**FEDERAL AVIATION ADMINISTRATION
AIRWORTHINESS DIRECTIVES**

BIWEEKLY 2018-08

4/2/2018 - 4/15/2018

2018-07-03 Piper Aircraft, Inc: Amendment 39-19234; Docket No. FAA-2018-0245; Product Identifier 2018-CE-012-AD.

**Figure 1 to the Appendix of AD 2018-07-03, Plane View
Fuel Selector Cover Configurations – Location and Identification**

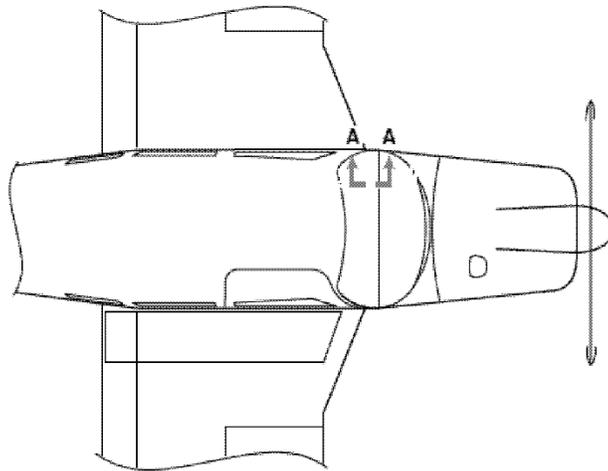
(1) Compare the currently installed fuel selector cover against the covers shown in Figure 2, View A-A:

(a) If the currently installed fuel selector cover matches the cover shown in Figure 2, View A-A, then proceed to Step 2.

**Figure 2 to the Appendix of AD 2018-07-03, View A-A
Fuel Selector Cover Configurations – Location and Identification**

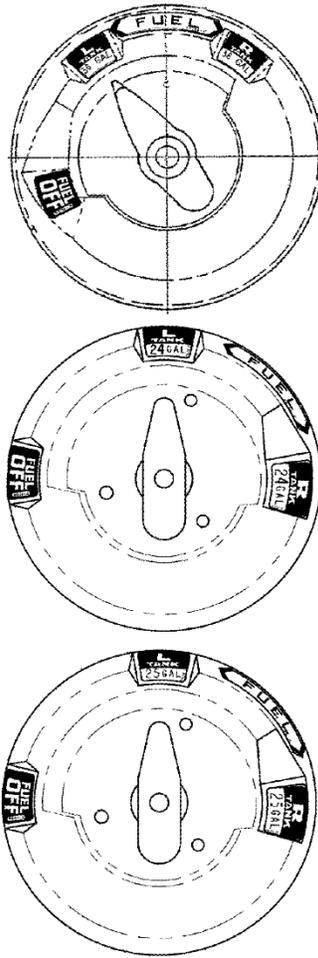
Note: The pictures are exemplar only to indicate the position of the FUEL OFF, L TANK and R TANK orientation of the placards. The most important aspect of this comparison is the orientation of the FUEL OFF, L TANK, and R TANK placards.

Note: The fuel tank capacity stated on the L TANK and R TANK placards will vary by aircraft model, but the location of these placards with respect to the fuel selector cover must all conform to View A-A

(2) Compare the currently installed fuel selector cover to the illustration in Figure 2, View A-A. Examine all placards for proper placement, with specific emphasis on the location of the placards labeled L TANK and R TANK.

Note: The fuel selector cover placard positions will vary. See Figure 2, View A-A.

(a) If the placards are in the proper locations, then no further action is required. Compliance with this part AD 2018-07-03 must be documented by the owner/operator (pilot) holding at least a private pilot certificate, and must be entered into the aircraft records showing compliance with this AD in accordance with 14 CFR 43.9 (a)(1)-(4) and 14 CFR 91.417(a)(2)(v). The record must be maintained as required by 14 CFR 91.417, 121.380, or 135.439.

(b) If replacement is required, proceed to either paragraph (h) and (i) of AD 2018-07-03.
